TOWN OF GLASTONBURY
GL-2021-05
GLASTONBURY HIGH SCHOOL ATHLETICS FACILITY
ADDENDUM NO. 2
December 10, 2020

A. RFI Questions and Answers:

C. Drawing Clarifications/ Revisions:

Connector Roof Alternate

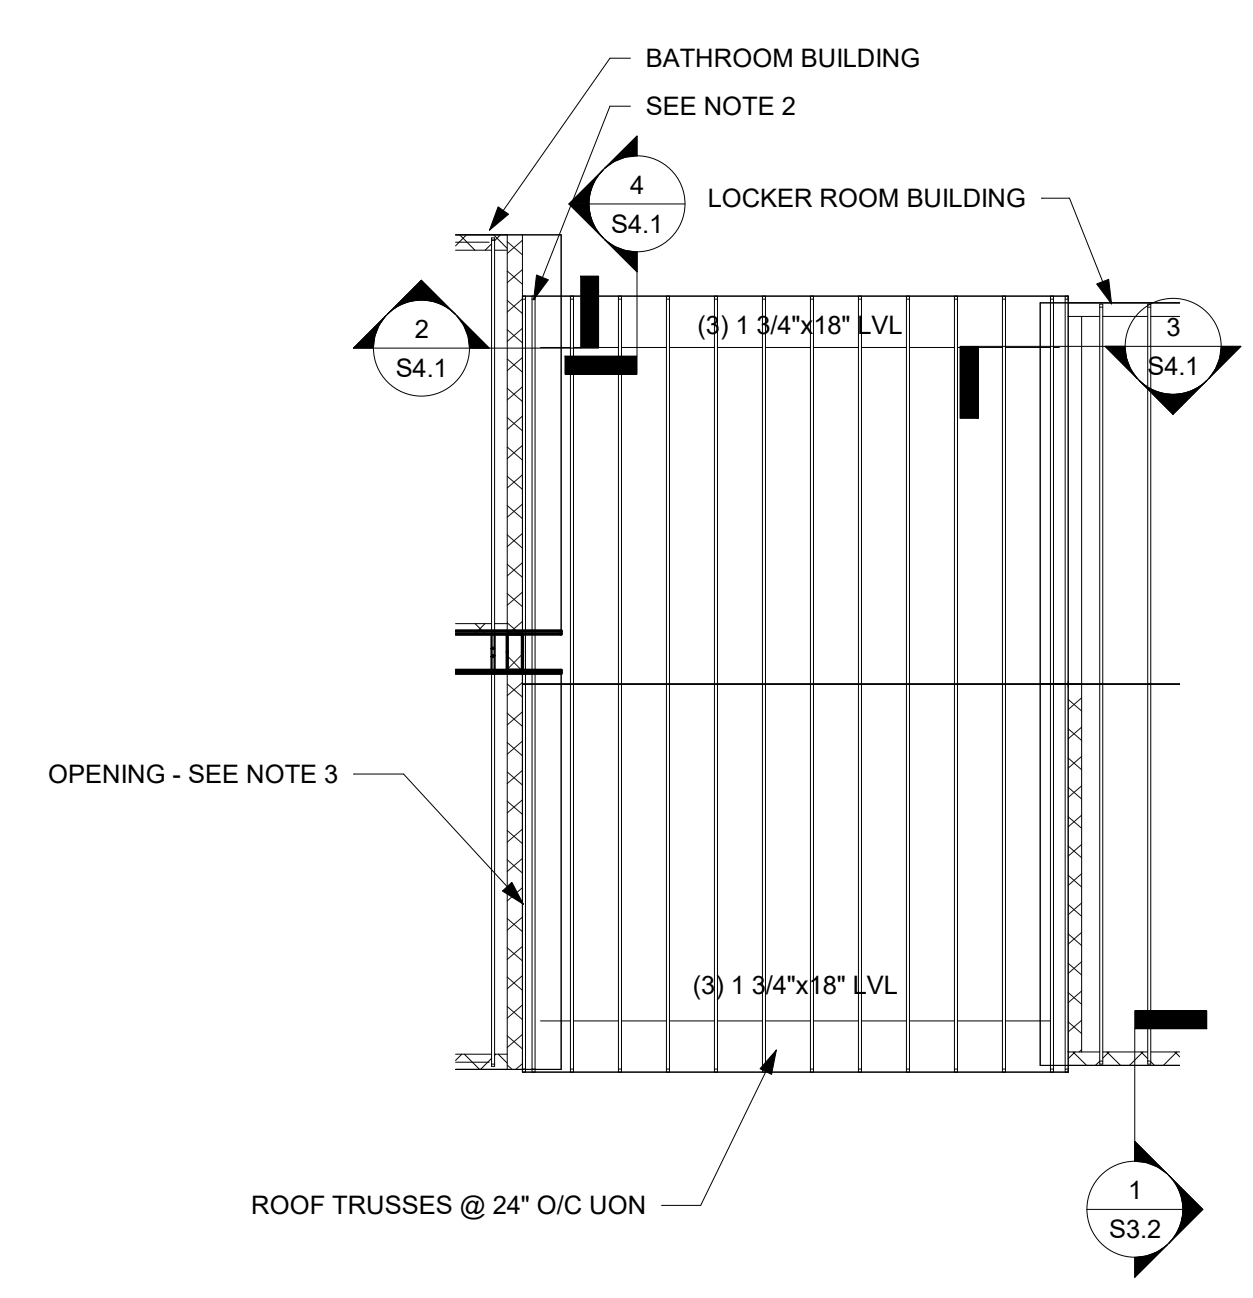
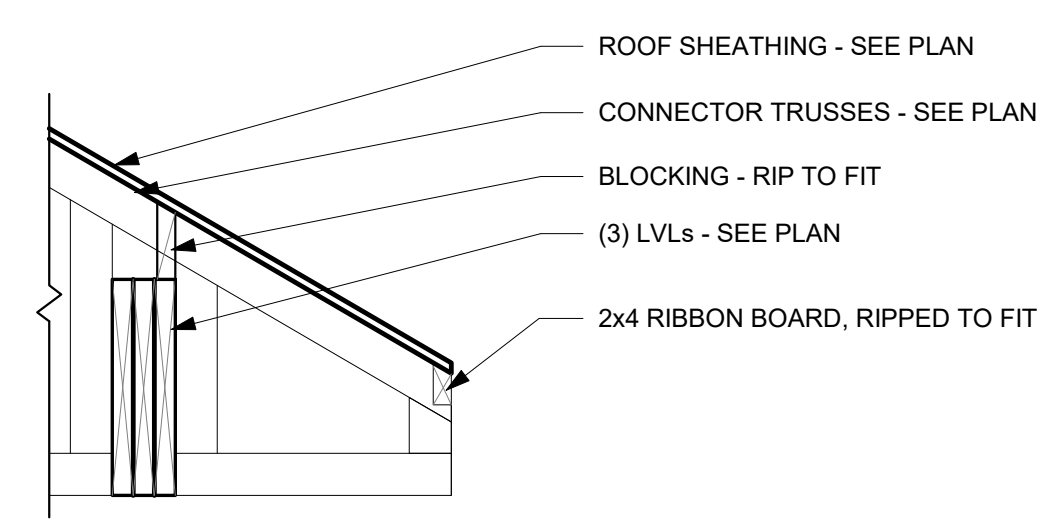
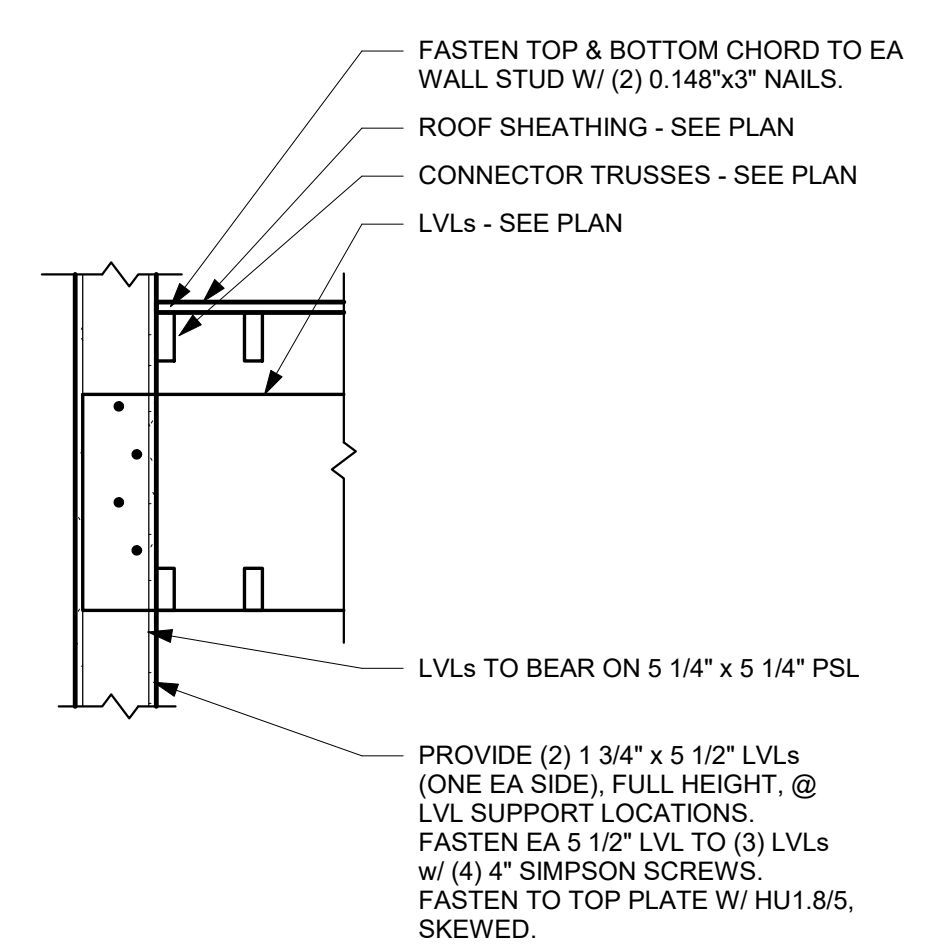
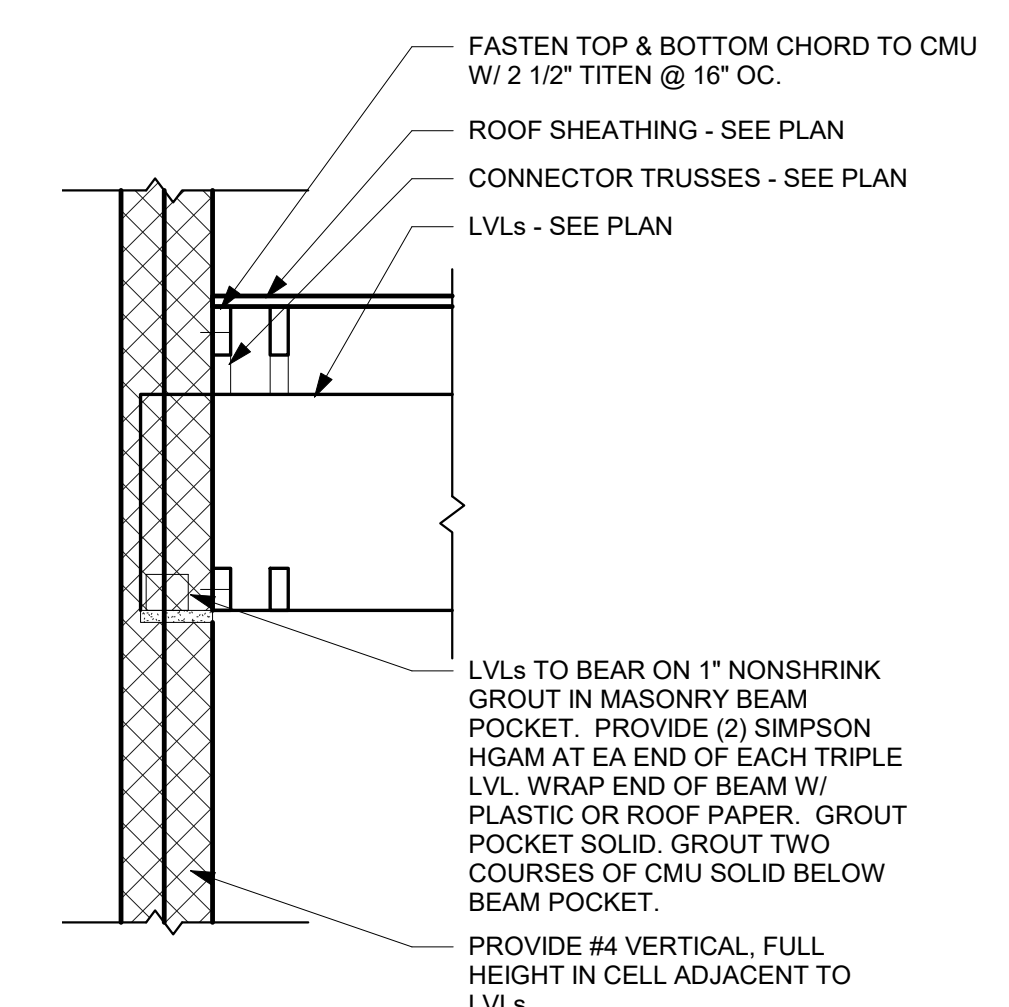
Question 28: *Drawing A-301 shows the Breezeway roof connecting the 2 structures. However, there are no cross sections, details, or structural drawings for this roof section. Please provide.*

Answer: Refer to A-301 and S4.1 included with this addendum for added details, sections, and structural details.

Item #5	C-5.0		REPLACED drawing C-5.0 with revised drawing dated 12/10/2020
Item #6	S-4.1		ADDED drawing S4.1 “Connector Roof Alternate”
Item #7	A-301		REPLACED drawing A-301 with revised drawing dated 12/10/2020. ADDED reflected ceiling plan, building sections, and details describing Alternate #1 Roof Connector.
